## SIMULATOR DISCREPANCY REPORT

REF. NO. LM-1AM-89

FUNCTION IN QUESTION PAC load of FRANK 32 shifted up one address.

**FLOW CHART - Fixed Memory  
Loading and Verification  
For PAC-LGC FMES  
FCI LAB.**

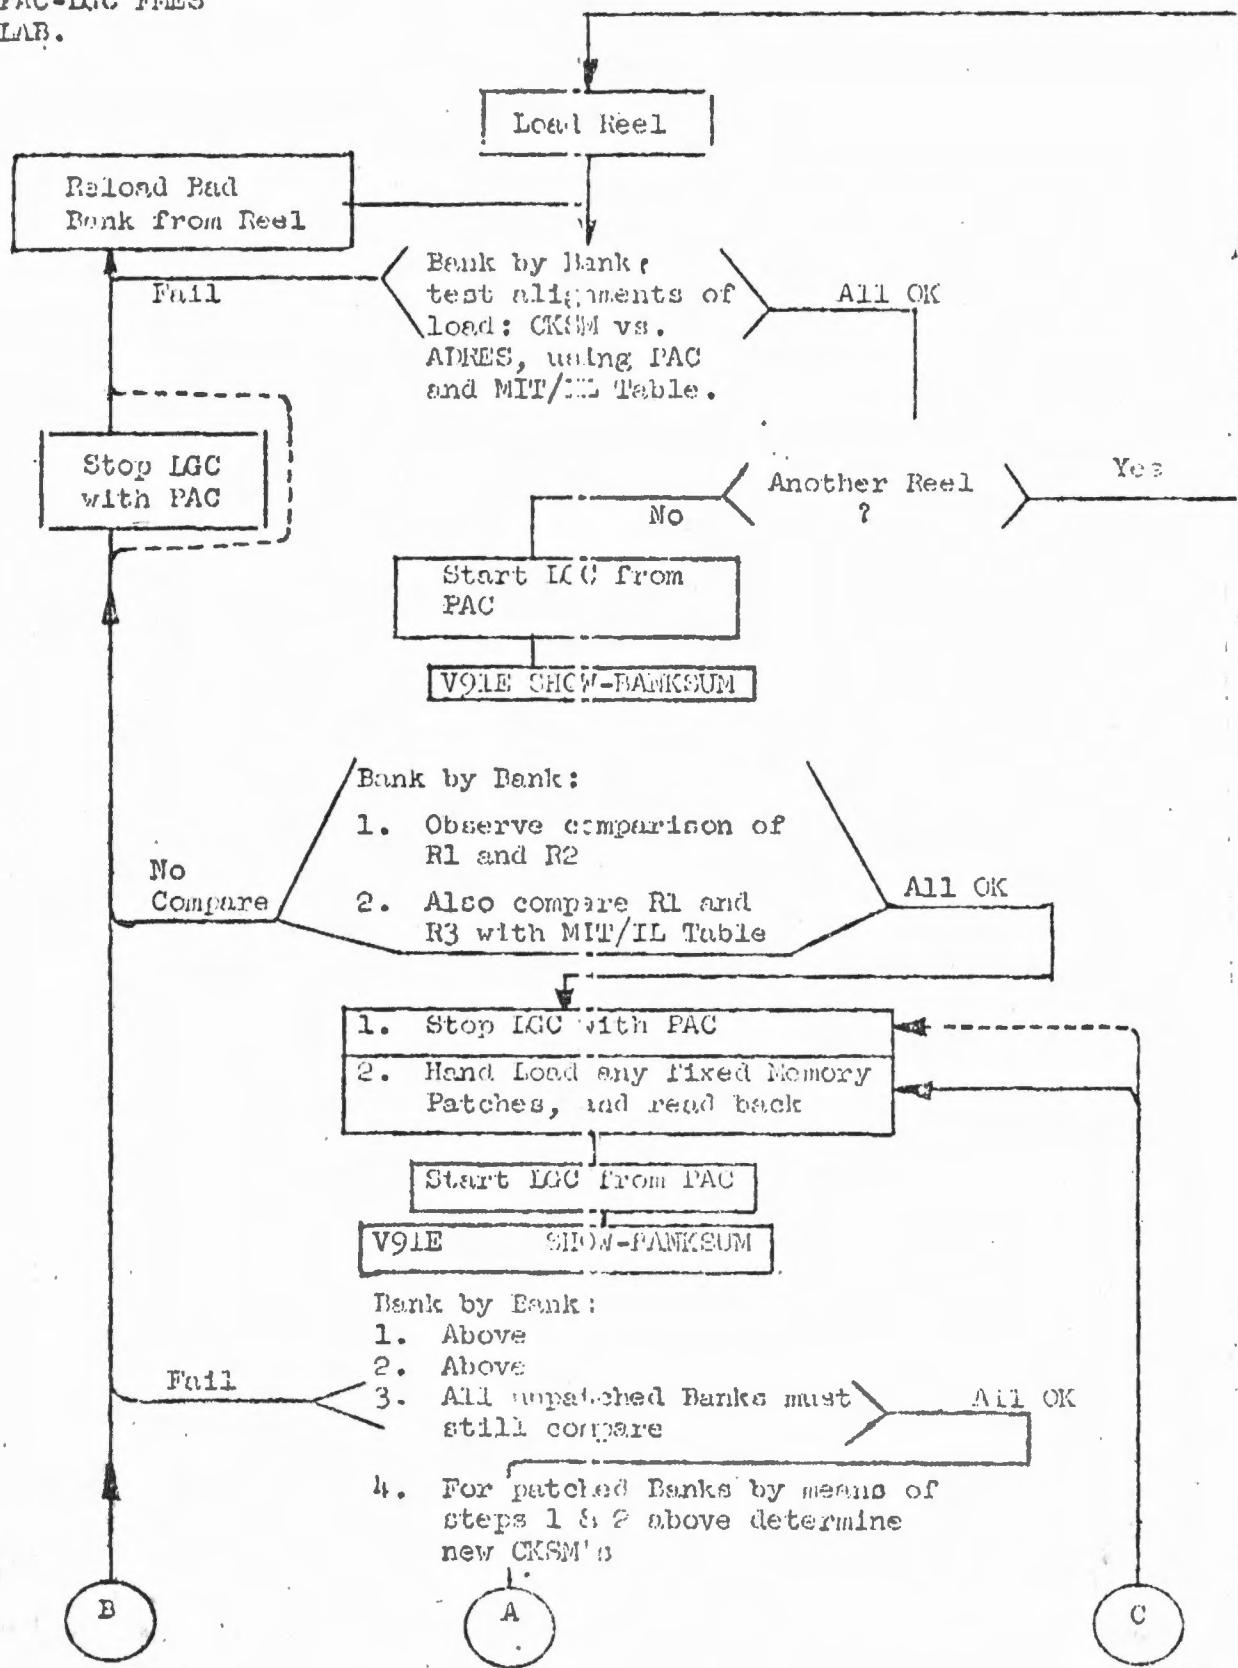
2. Institute the fixed memory loading and verification sequence for the PAC - LGC shown in the attached flow chart. Comments on the verification flow chart, follow.

- a. The test on the PAC of the CKSM's vs their addresses should pick up a misalignment such as discussed in this report. Note that some misalignments could prevent LGC operation so that a check should be done before attempting to start the LGC. A tape compare could be done, but this is a time consuming operation. It is felt that the arrangement here permits the loading to progress as rapidly as possible.

- b. The V5M1 displays in V91 show the actual bank sum in R1 and the bank number in R2. They may compare true/true or not/true. Apparently either of these conditions in themselves does not assure a proper load in a bank. The true or not condition in R1 should be checked with the MIT/IL table as well as the content of R3.

- c. Until a table such as requested in Recommendation 3. is available, GAC should prepare a table of the Bank No's, the CKSM addresses and their contents.

- d. The more lengthy tape compare is done once at the end where it should show only the properly placed Fixed Memory Patches. This is a comprehensive check that these patches are in their proper locations and that no other locations have been disturbed in the process.

- e. If a hard copy record dump is desired it could be done after the tape compare or after the last V91E SHOW - BANKSUM check. The former is probably preferable since this must be done with the LGC off (under PAC control) and the last V91 is basically a final check that the F Memory with the LGC running is properly loaded.
